Murdoch & Murray's  
No. 125

DRAWING No 2108.  
SCALE 1/4 INCH TO A FOOT.

ARRANGEMENT OF PLATING  
AT BREAK  
S.S. No 125

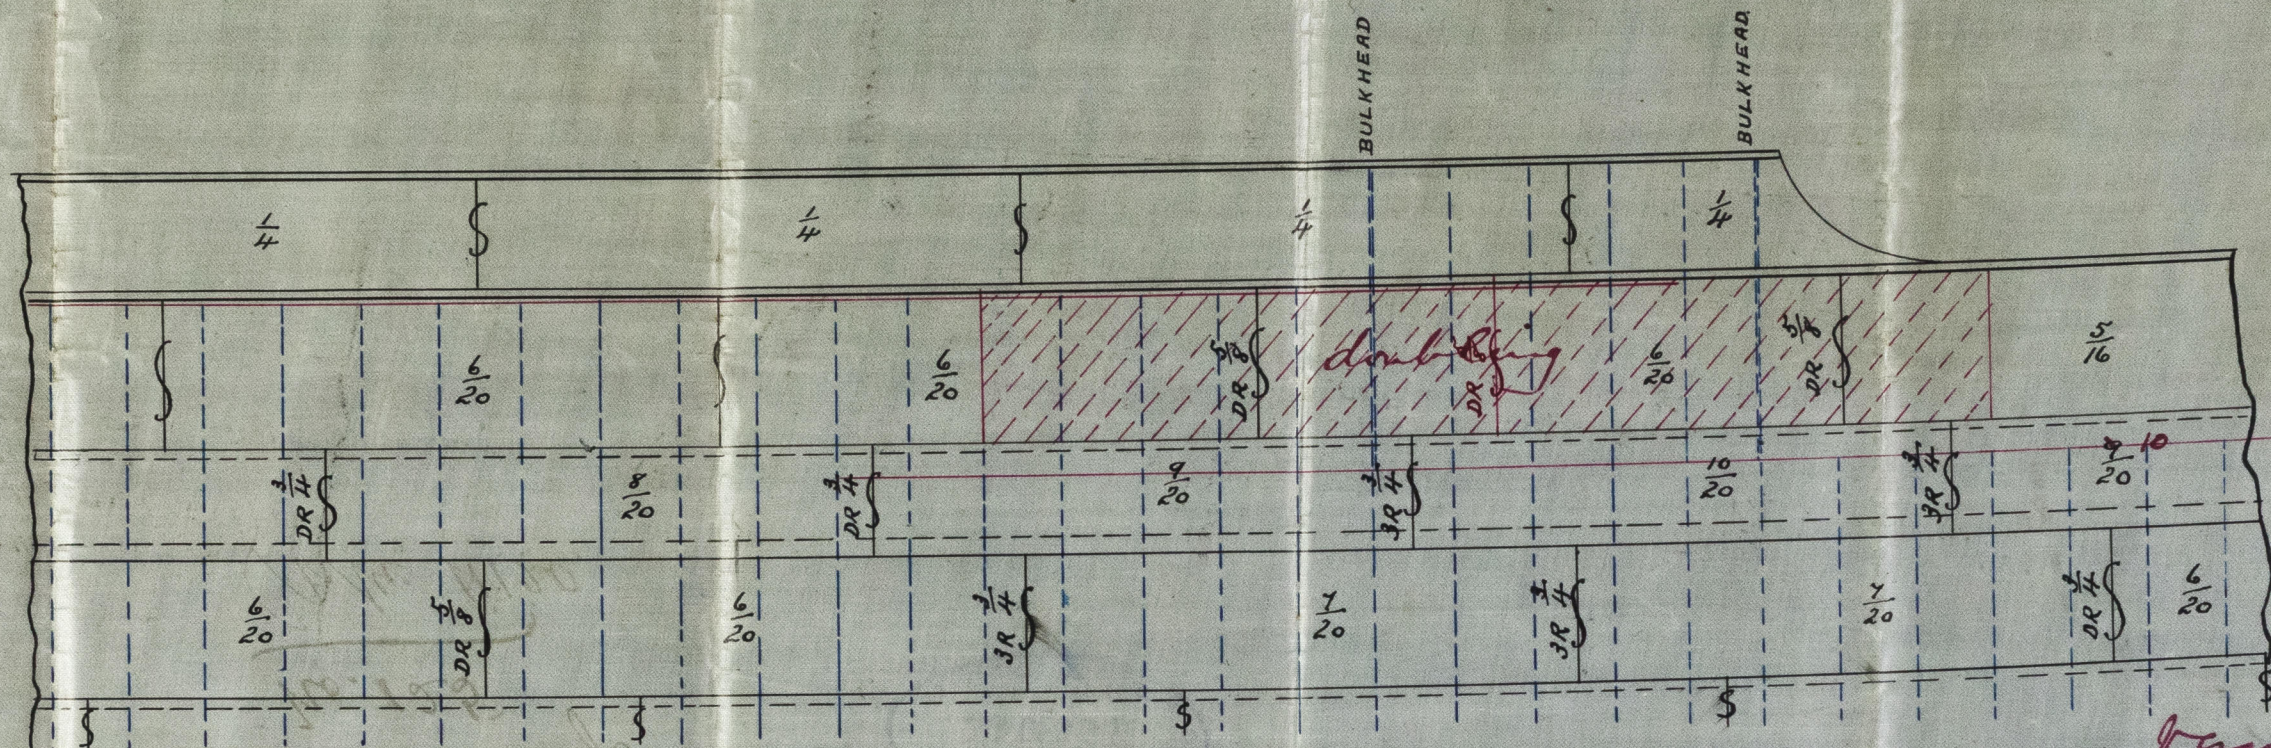
NOTE Increased thickness in those two strakes is in lieu of sheerstrake doubling at front of bridge.

Used additionally strengthened at break to surveyor's satisfaction.
